## Shop Drawing Submittal Review

Project Name: Webster University-**ISB**

PROJECT NAME: Webster University  
 LOCATION: ISB  
 CLIENT PROJ. NO.: St. Louis Missouri  
 WES PROJ. NO.: N/A  
 607  
 SPEC SECTION: 22 1423 Storm  
 Drainage Piping  
 Specialties  
 SUBMITTAL ITEM: See Below -

**OD-1**

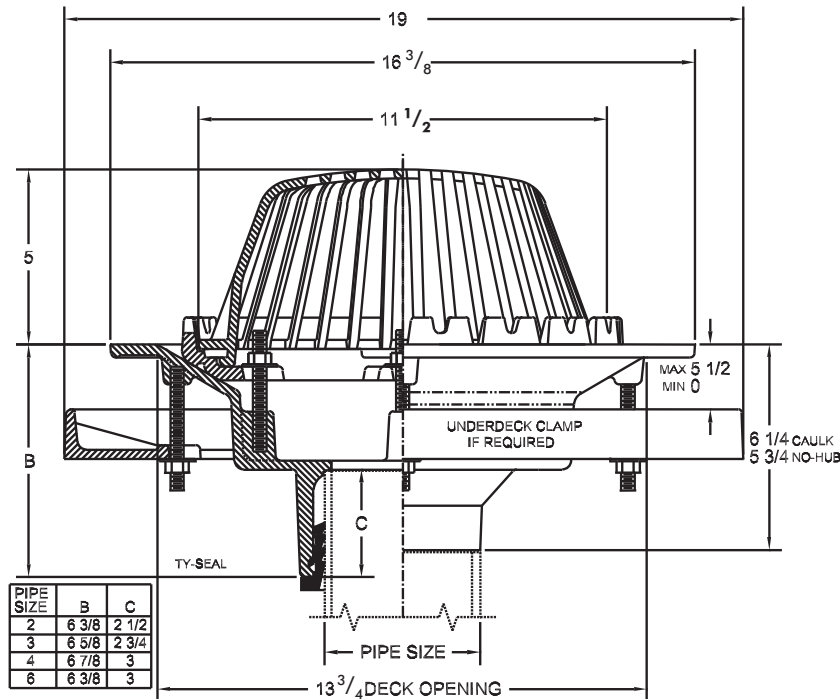
| X   |                    |                                         |                    |                        | Roof Drain – OD-1<br>Wade<br>Model 300042xNH5253SD |                                                       |
